**TO:** Design Advisory Board  
**FROM:** Ken Lerner  
**DATE:** November 12, 2014  
**RE:** 15-0525CA/MA, 87-95 North Avenue & 7 Haswell Street

**Request:** Renovation and addition to existing building for 14 new residential units as part of mixed use building. Project includes demolition of house and lot merger at 7 Haswell Street. Uses in addition to the residential units will include adult day care (Day Station) and COTS offices.

COTS 95 NORTH AVENUE

EAST ELEVATION - PROPOSED  
Scale: 3/32" = 1'-0"

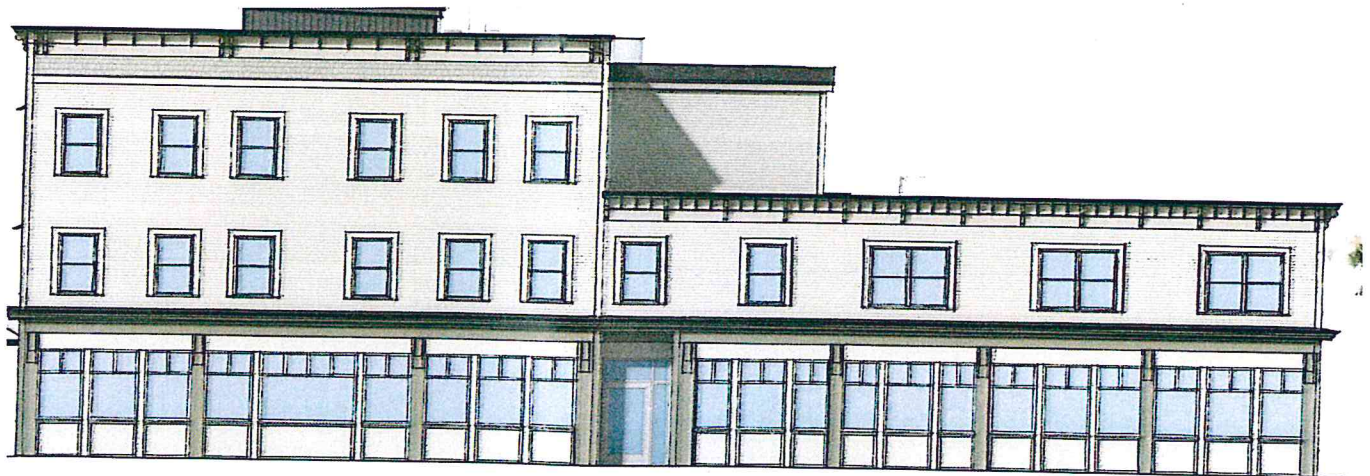
All elevations contain well defined and appropriate patterns. The plan for the east elevation depicts a consistent fenestration pattern with commercial store front windows at the ground level in an attempt to recreate the original retail use.

The applicant states that roof top HVAC units are located to be concealed or otherwise located to minimize visibility by pedestrians. However, this standard requires that *such features, in excess of one foot in height, shall be either enclosed within the roof structure, outer building walls, or parapets, or designed so that they are integrated into the overall design and materials of the building. Where such rooftop features do not exceed ten percent (10%) of the total roof area, they may be considered "ornamental and symbolic features" pursuant to Sec. 5.2.7 for the purposes of measuring building height.* This needs to be addressed as the illustrations depict a fairly large amount of roof top mechanicals.

6. The applicant states that roof top HVAC units are located to be concealed or otherwise located to minimize visibility by pedestrians. As roof top *features, in excess of one foot in height, shall be either enclosed within the roof structure, outer building walls, or parapets, or designed so that they are integrated into the overall design and materials of the building. Where such rooftop features do not exceed ten percent (10%) of the total roof area, they may be considered "ornamental and symbolic features" pursuant to Sec. 5.2.7 for the purposes of measuring building height*, this will need to be addressed as the illustrations depict a fairly large amount of roof top mechanicals.
